A96	OBC Crossbar Serial Mux		proj 879720		Sheet/of	
	A. Bradley	V-21-2004	rev.2 XI-9-2004		1	2

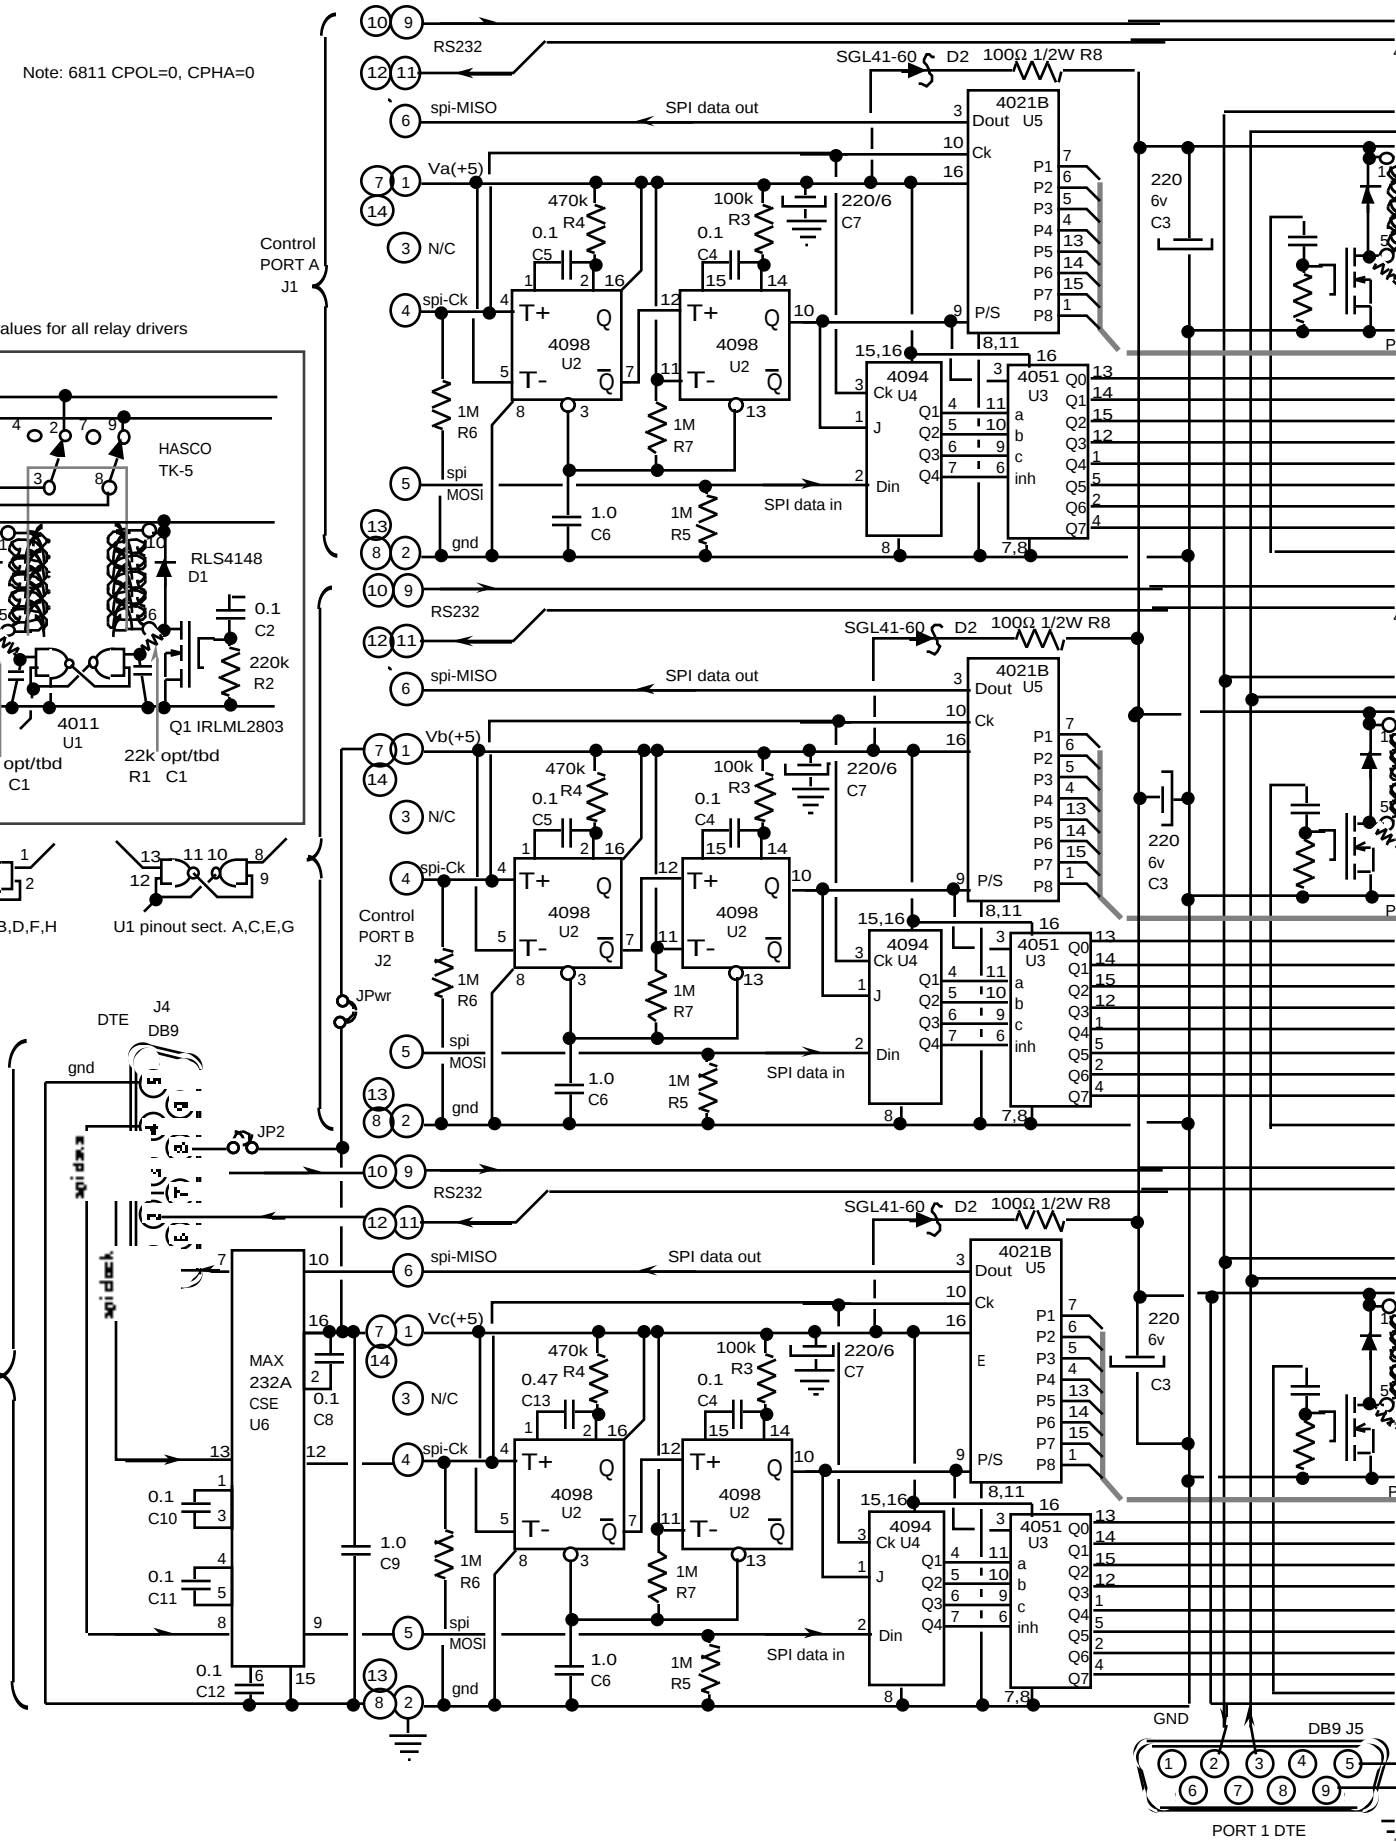
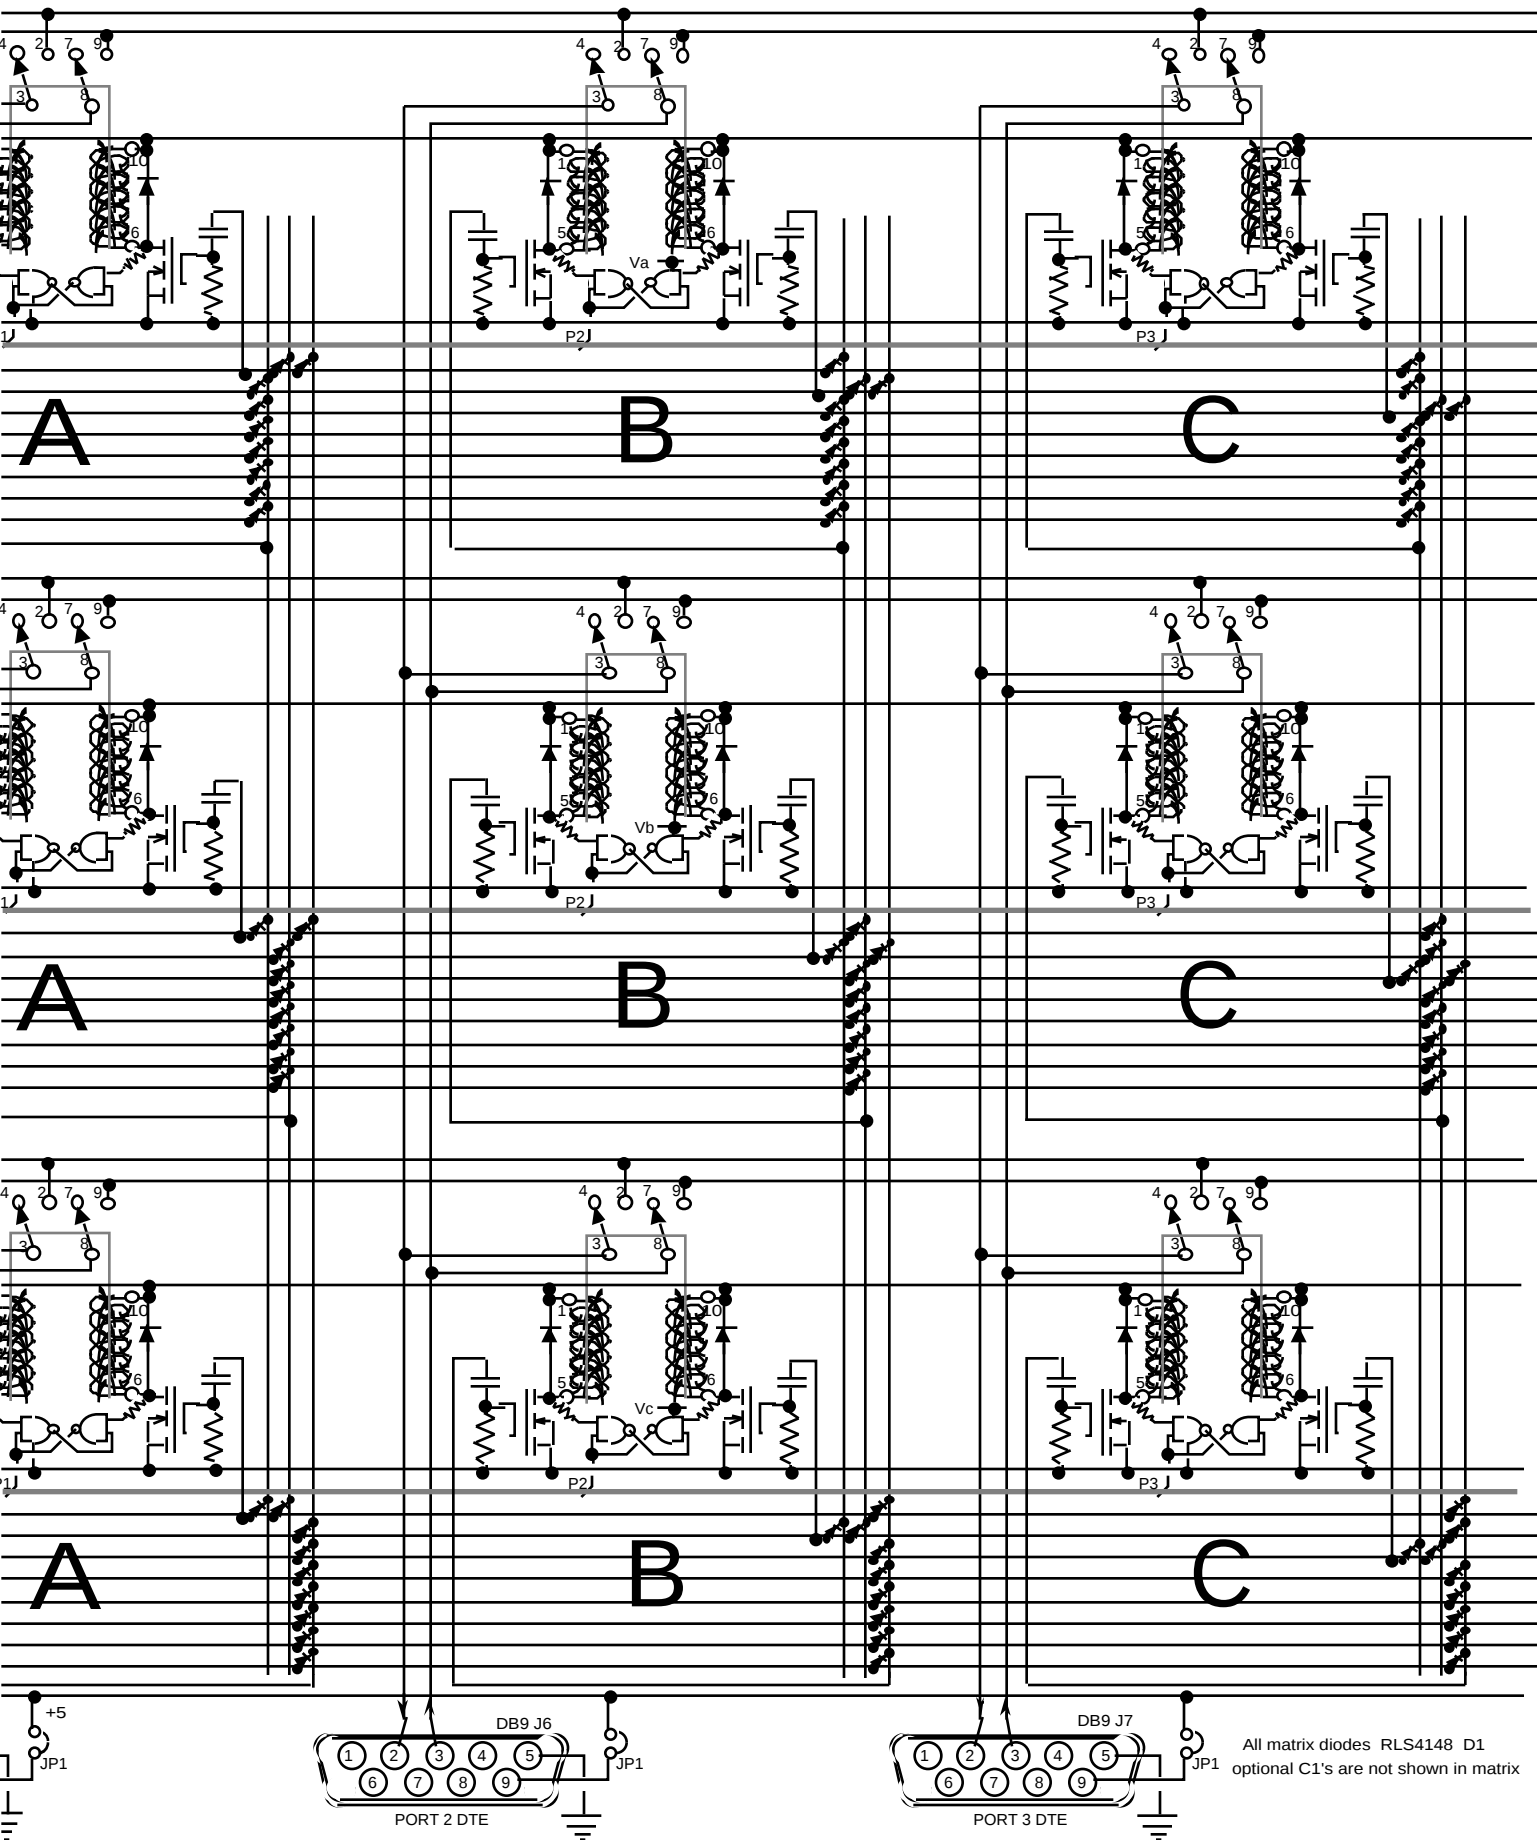
Rev 2 - relay drive on/off reversed at C2, sense was not swapped, JPwr added, JP2 moved to p8
